TOWN OF COTTAGE GROVE
PLAN COMMISSION MINUTES
APRIL 23, 2025

To: Town of Cottage Plan Commission
FROM: Mark Roffers, Town Planner
DATE: May 19, 2025
RE: Viney Acres Business Park Rezoning and Preliminary Plat

To: Town of Cottage Plan Commission
FROM: Mark Roffers, Town Planner
DATE: August 18, 2025
RE: Skaar Pit (Huston) Business Park Concept Plan/Comprehensive Development Plan

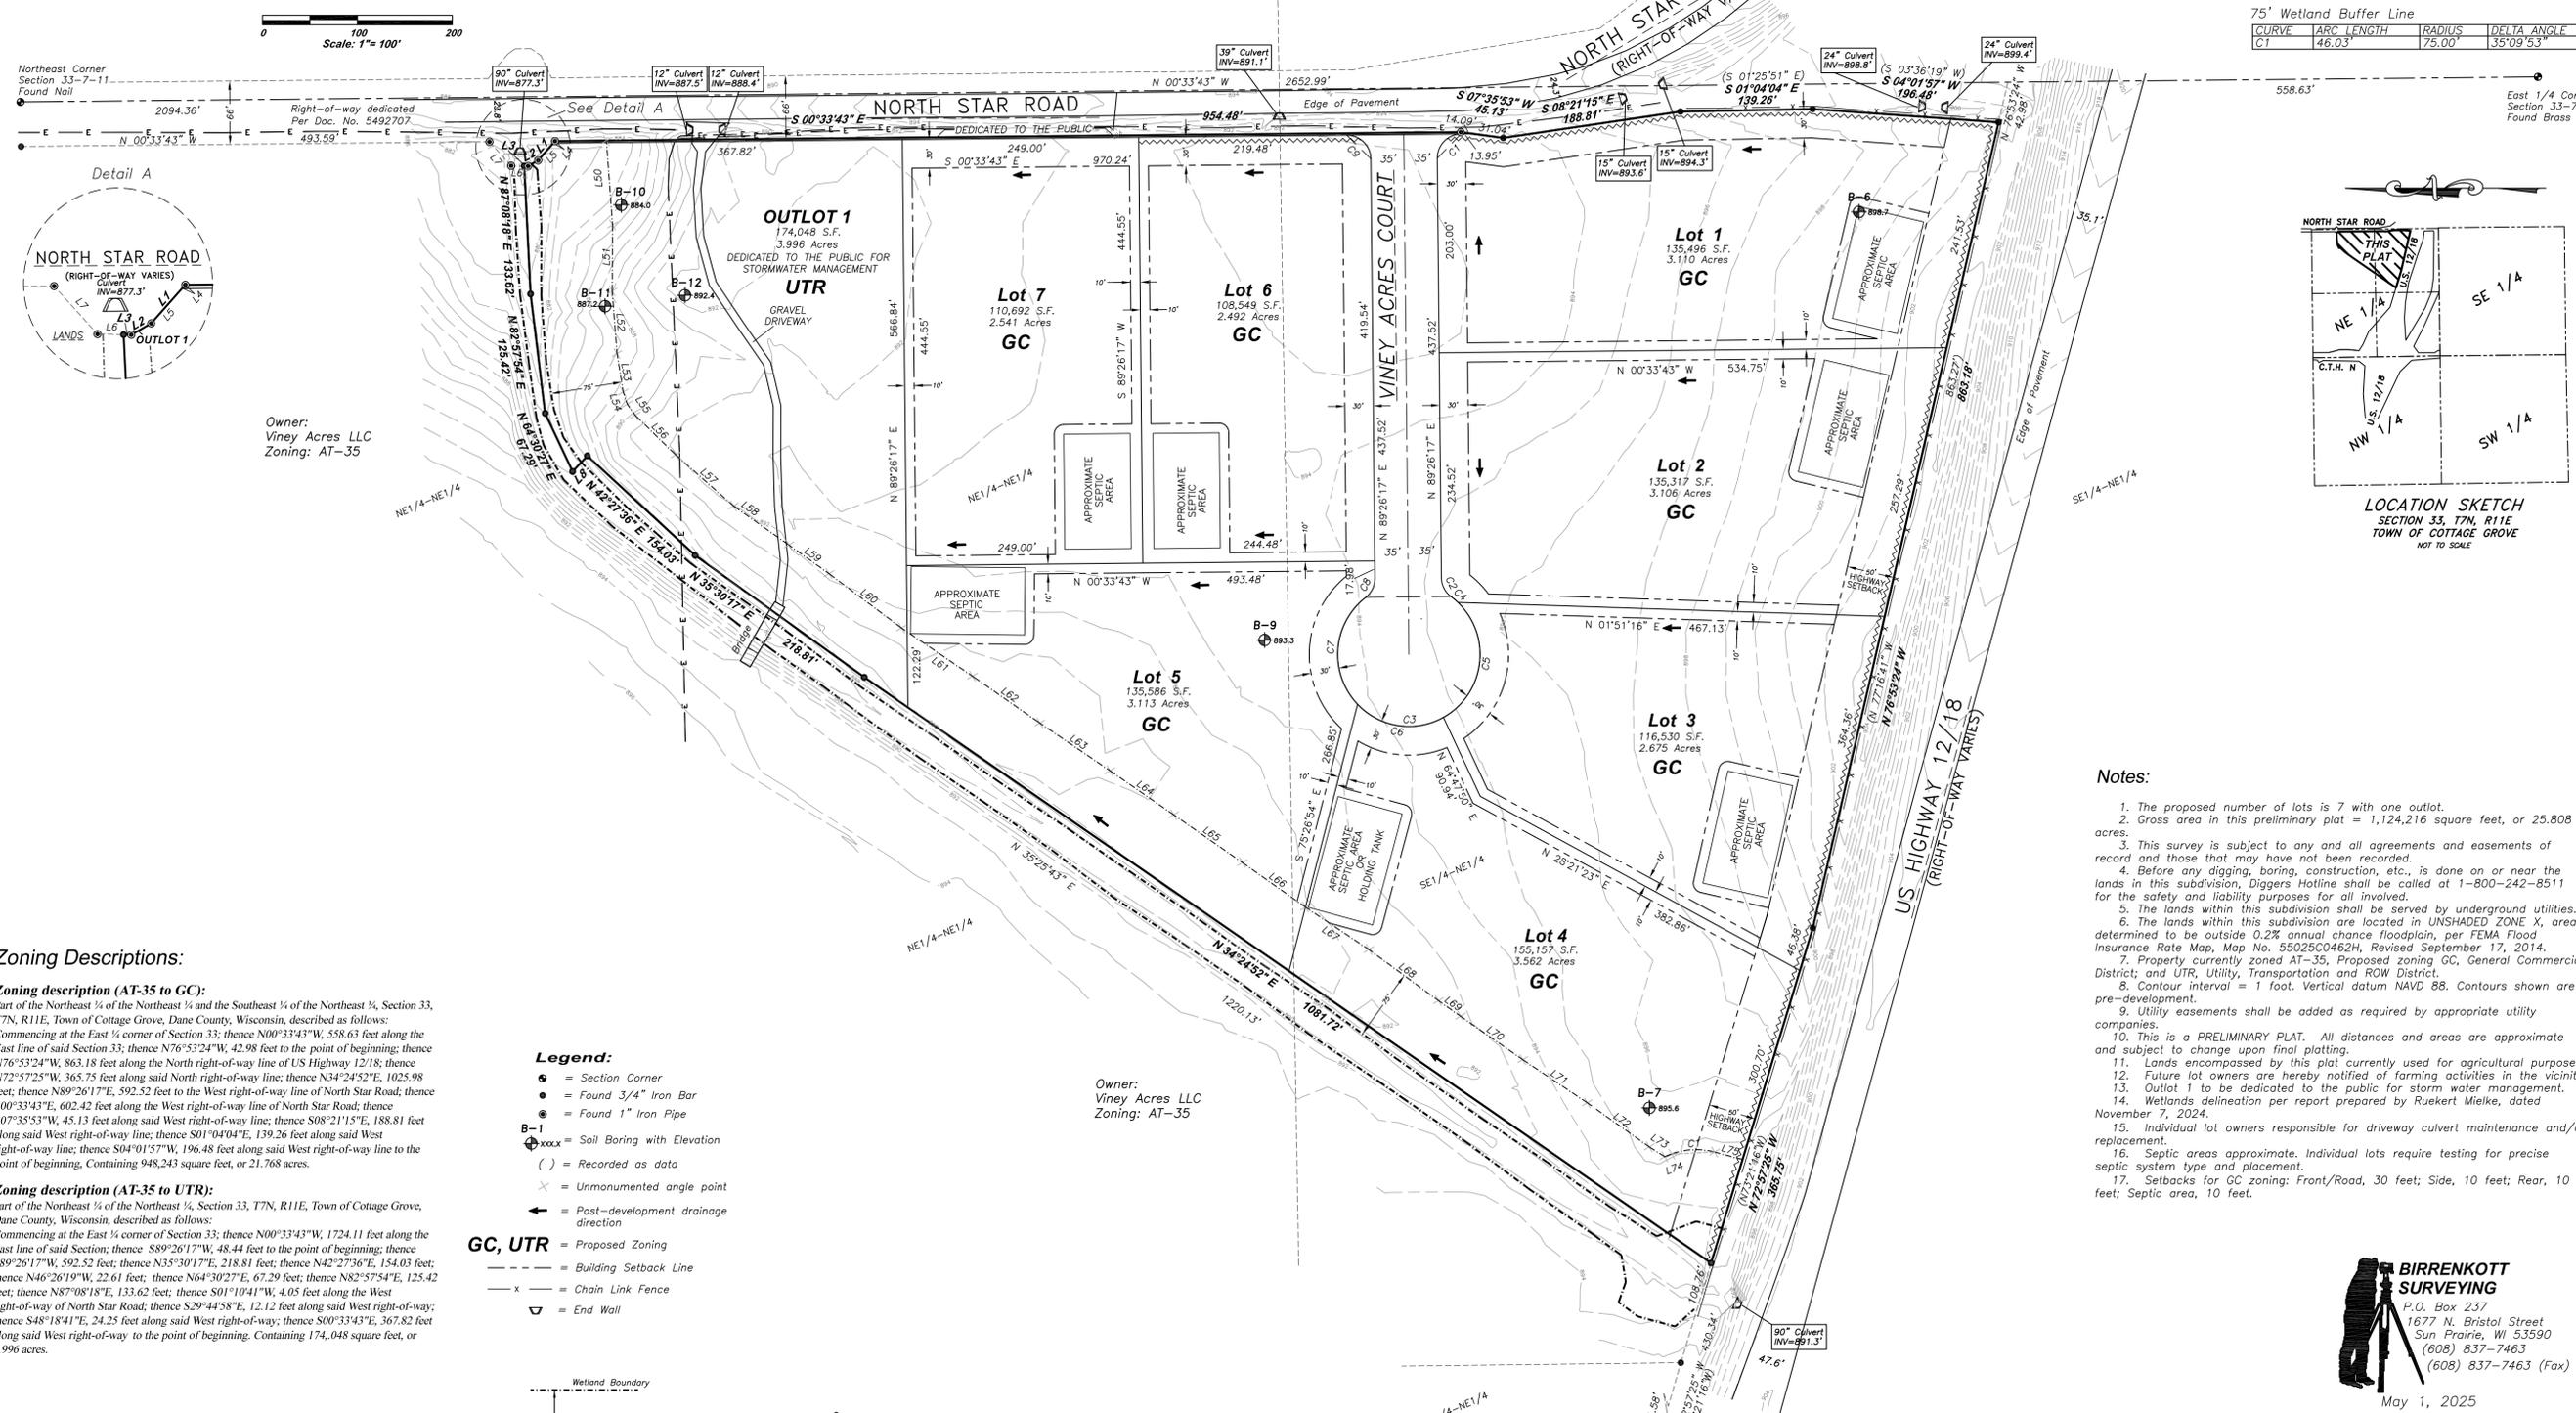
- a. Confirm Viney Acre Court cul-de-sac road name with Dane County, and change name if necessary. Reduce its right-of-way width to 66 feet and engineering plans accordingly.

- b. Provide vision triangles at the corner of North Star Road and the public cul-de-sac.
 - c. Provide a highway setback along Highway 12/18, verifying with DOT whether it should be 42 or 50 feet, and include any restrictions required by DOT in association with that setback.

- d. End the “no vehicle access” restriction along North Star Road 20 feet from the northeast corner of Lot 6. Provide along the Lot 6/7 edge a “shared access easement between Lots 6 and 7”.

- e. As indicated in Snyder’s preliminary engineering plans, indicate “public stormwater management easements” around the cul-de-sac street, between that street and Outlot 1, and in the 55 to 65 foot easement area along the rear lot lines of Lots 3 and 4. Provide a separate easement document for recording indicated rights and responsibilities, if advised by the Town Attorney or Engineer.

- g. Indicate changes to the size and shape of Outlot 1 as may be required following preparation and review of final stormwater management plans and calculations.

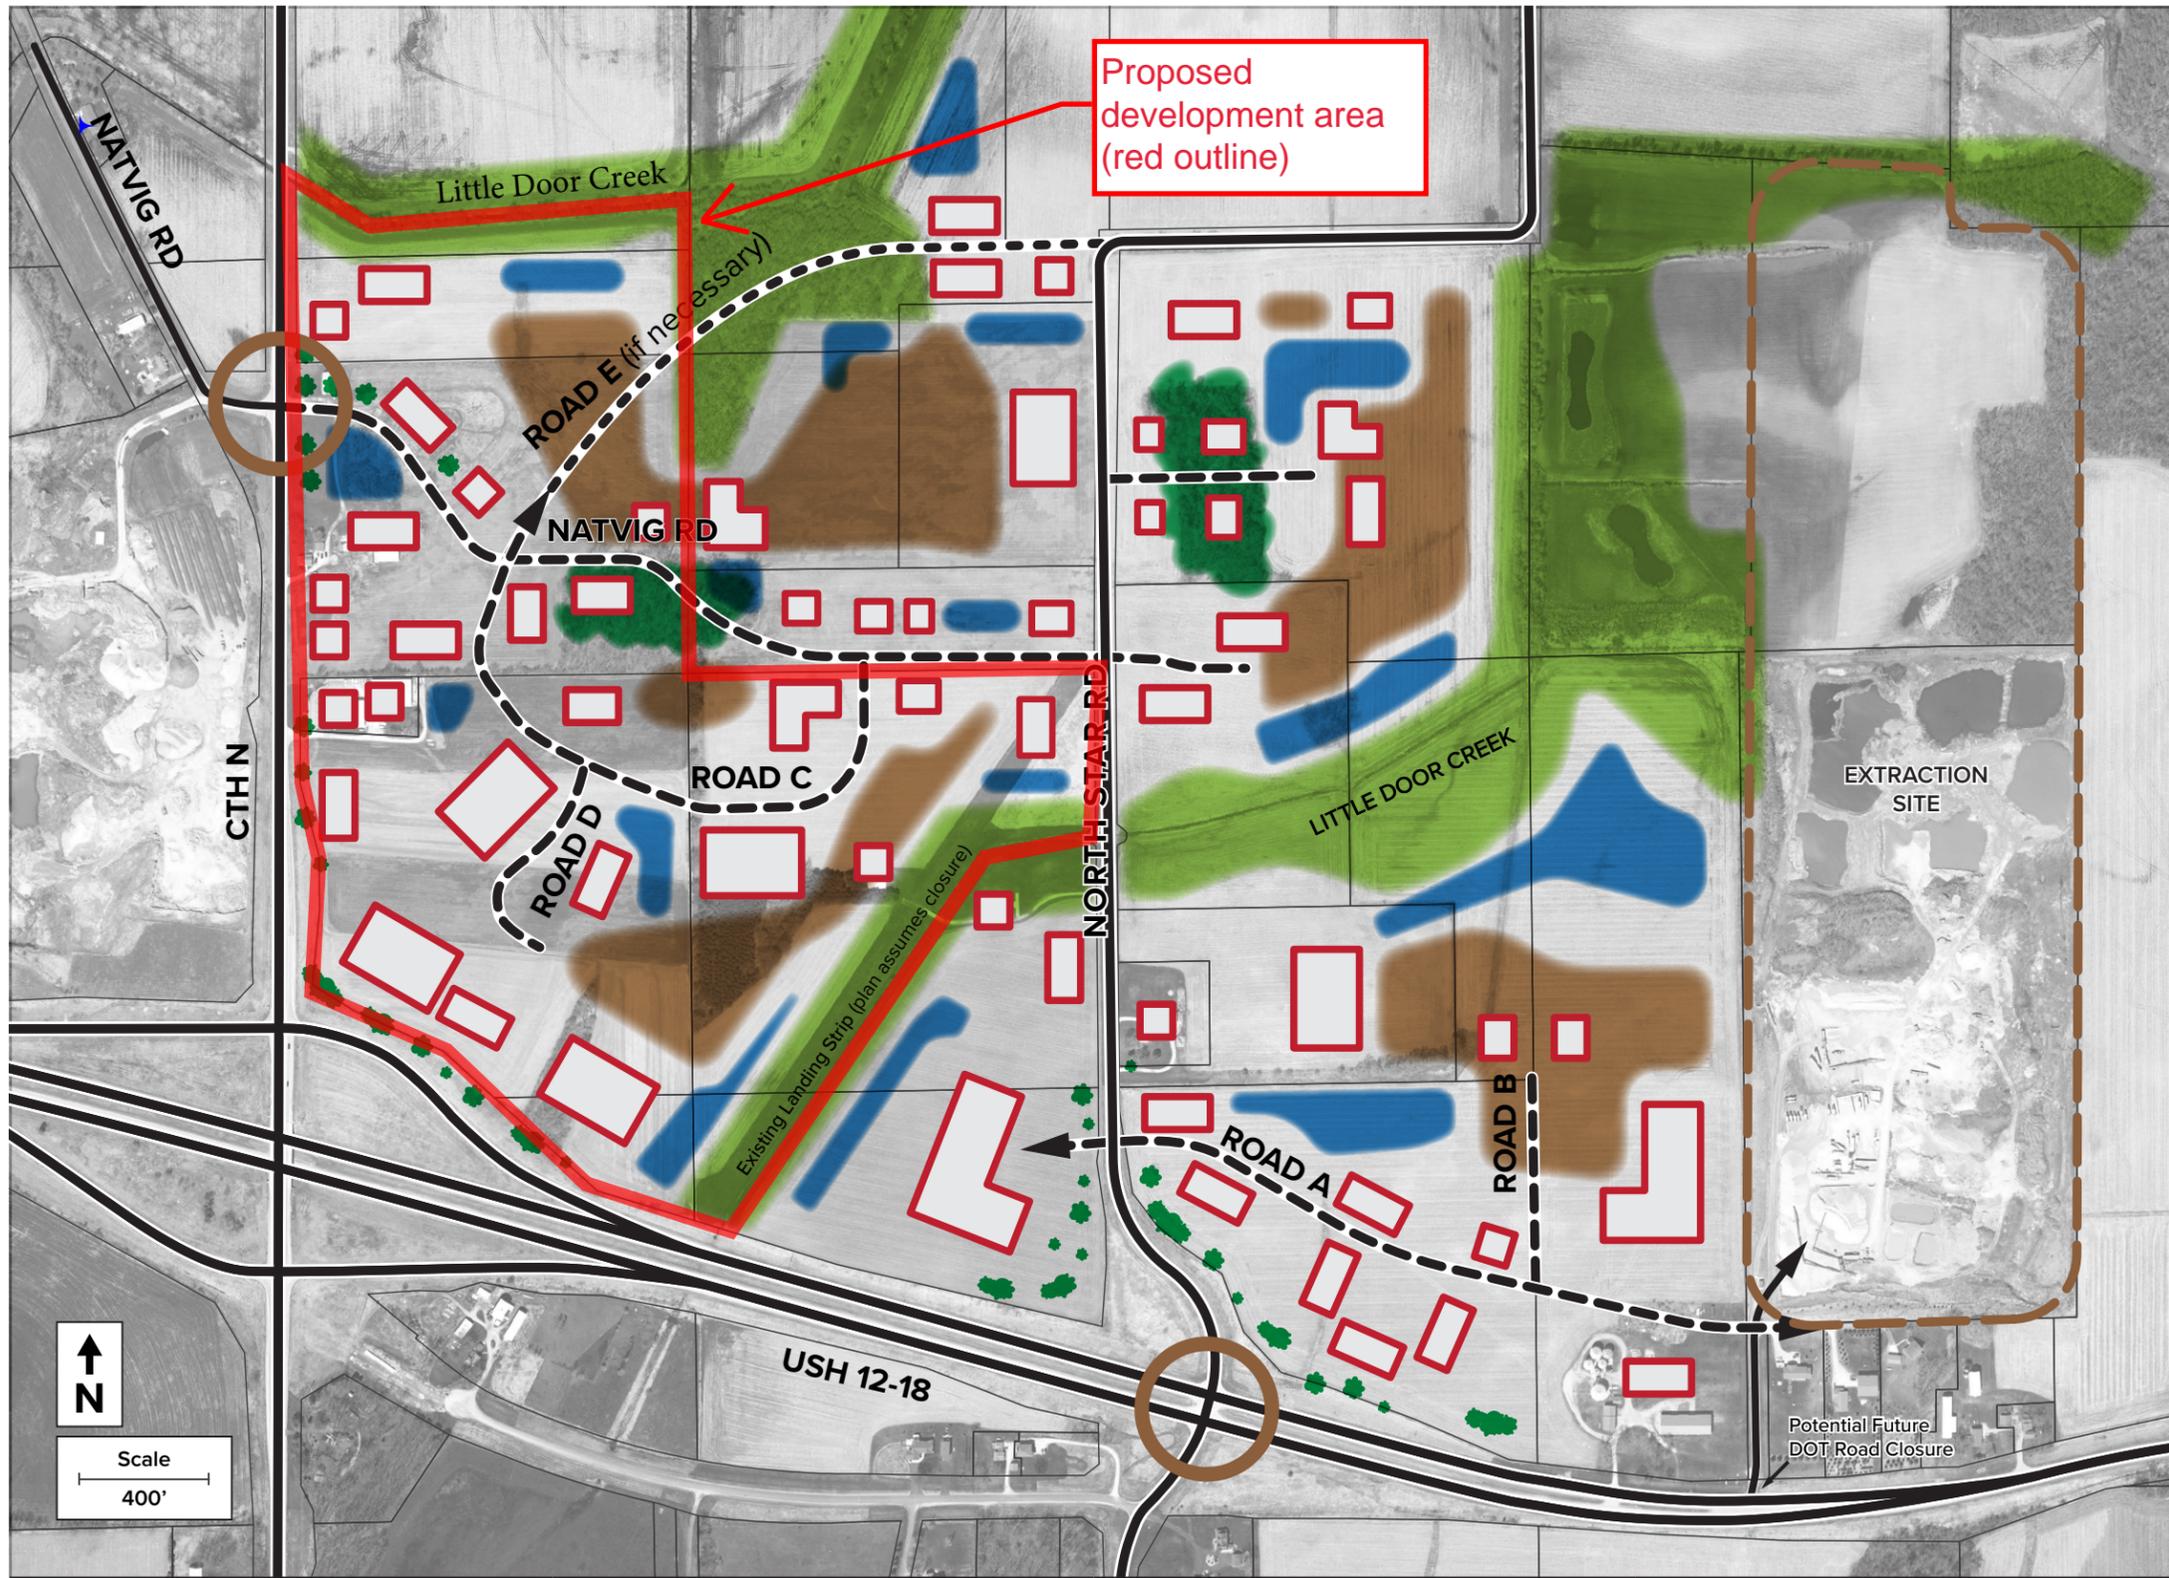
1. Relationship to Town Plan: This proposed business park is consistent with and advances the Town Comprehensive Plan. It has potential to result in significant tax base growth, also with additional infrastructure and service expense. The Plan advises this property as part of a larger planned “Commercial Development Area” in the North Star Road corridor (see attached map), subject to the following comments:

- a. Figure 9 of the Comprehensive Plan suggests uses “that emphasize storage (particularly outdoor storage) and outdoor display and activities should be minimized.” The attached Conceptual Rural Business Park Development Plan map is part of the Town Comprehensive Plan. Per that map, some more interior parts of this proposed development are indicated as acceptable for larger outdoor storage yards (brown) due to lower highway visibility. Covenants or conditional use permit requirements (like what applies under GC zoning) may limit outdoor storage uses on some other lots or more exposed parts of larger lots like proposed Lot 1.

- b. GC and HC zoning districts are listed among the “typical implementing zoning districts” for the Town’s planned “Commercial Development Area”. The petitioner seems to be interested in all HC zoning. I advise rezoning of proposed Lots 2-4 along Highway N, at least, to the GC district instead. The Paul Davis lot (most of Lot 2) is already zoned GC. The Town Plan also advises that the Town will sometimes limit the range and scale of land uses through deed restrictions. As the petitioner’s initial submittal suggests, a deed restriction should also be applied to restrict against the most objectionable HC uses for acceptable HC-zoned lands. I also advise outdoor storage locational and screening requirements for the large and highly-visible proposed Lot 1.

- e. The Town Plan suggests potential for a secondary road connection to the northeast (labeled “ROAD E (if necessary)” on attached map) to connect at the northern “bend” of North Star Road, through parcel 071128482510 (Larry Skaar). The feasibility of this secondary road is questionable given intervening low lands and steep slopes associated with a wooded drumlin. There may also be development interest from another party on at least part of this parcel 071128482510. For these reasons, I advise collaboration on the wetland delineation described below.

SITE PLAN:
PROPOSED

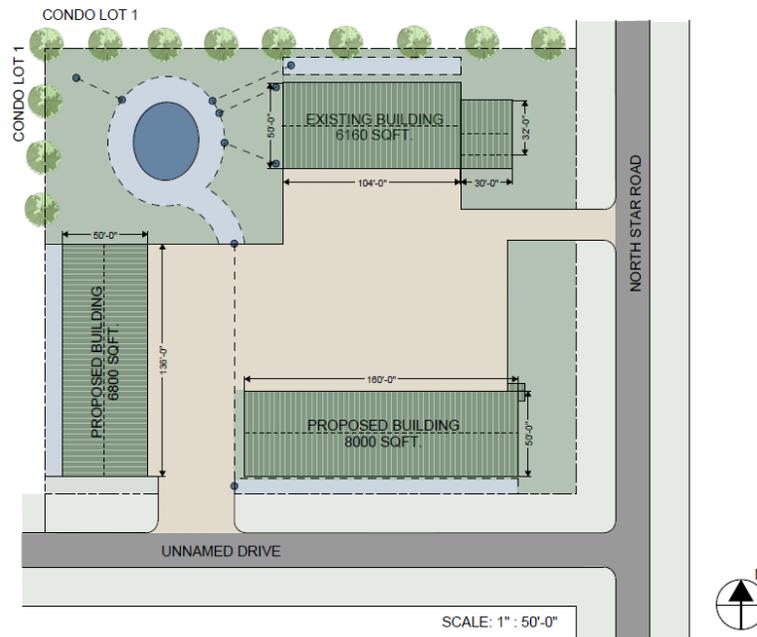
4. Put a date on the first page of the revised “NSRI Petition Support 2025” file so it can be easily referenced.
5. For the “Site Plan: Proposed” sheet, please:

- a. Add a date so it can be easily referenced.
 - b. Indicate which surfaces will be asphalt paved, and when, and which are proposed to remain gravel.

- c. Provide some more detail on the types (species) and sizes (at time of planting) of new trees and shrubs that are proposed.
 - d. Verify that all minimum building setback requirements required under the site’s G-C zoning will be met; label actual proposed setbacks of new buildings,

- g. Submit grading plan, even if it was previously approved grading plan and no changes are proposed. Provide finished first floor elevations of each proposed building.

- j. What is the apparent bump-out at the northeast corner of the southeast building. It doesn’t appear to be reflected on the Cleary building elevations. Don’t get me wrong—I would appreciate some sort of detail/bump out there, it’s just that the Cleary elevations for that building should reflect that.
